State of New Mexico
Energy, Minerals and Natural Resources

Form C-103
Revised August 1, 2011

WELL API NO. 30-025-25314
5. Indicate Type of Lease STATE <input checked="" type="checkbox"/> FEE <input type="checkbox"/>
6. State Oil & Gas Lease No.
7. Lease Name or Unit Agreement Name Scratchy Ranch AQC State
8. Well Number 1
9. OGRID Number 143199
10. Pool name or Wildcat Feather; Upper Penn, East

RECEIVED
SUNDRY NOTICES AND REPORTS ON WELLS
(DO NOT USE THIS FORM FOR PROPOSALS TO DRILL OR TO DEEPEN OR PLUG BACK TO A DIFFERENT RESERVOIR. USE "APPLICATION FOR PERMIT" (FORM C-101) FOR SUCH PROPOSALS.)

Well Name: **Scratchy Ranch ACQ State Unit #1**

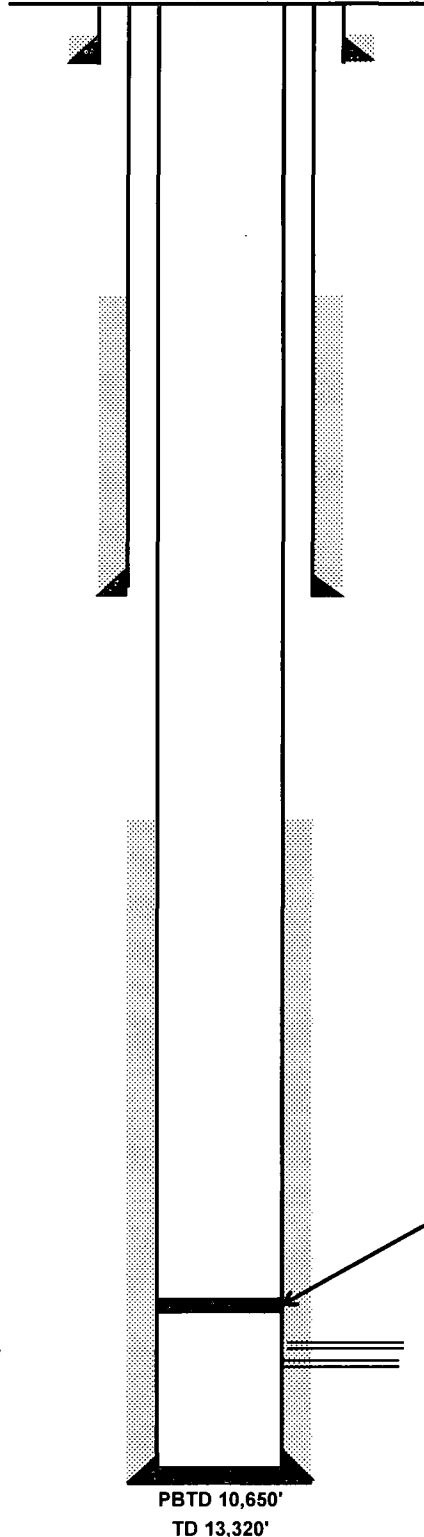
- Kill well if necessary w/2% KCL. Keep kill truck on location to use as needed.
- POOH w/rods and pump.
- NDWH, NUBOP and test.
- MIRU wireline & RIH w/4-1/2" CBP, set @ ~10,486'.
- Bail ~20" cmt on top of plug. → 35'
- Notify NMOCD of intent to demonstrate mechanical integrity.
- Load csg w/2% KCL & test to 600 psi. Chart test & wait for approval from NMOCD.
- ~~The Oil Conservation Division~~

Proposed CIBP @ 10,486' w/ 20' cement on top

Condition of Approval: Notify OCD Hobbs office 24 hours prior to running MIT Test & Chart
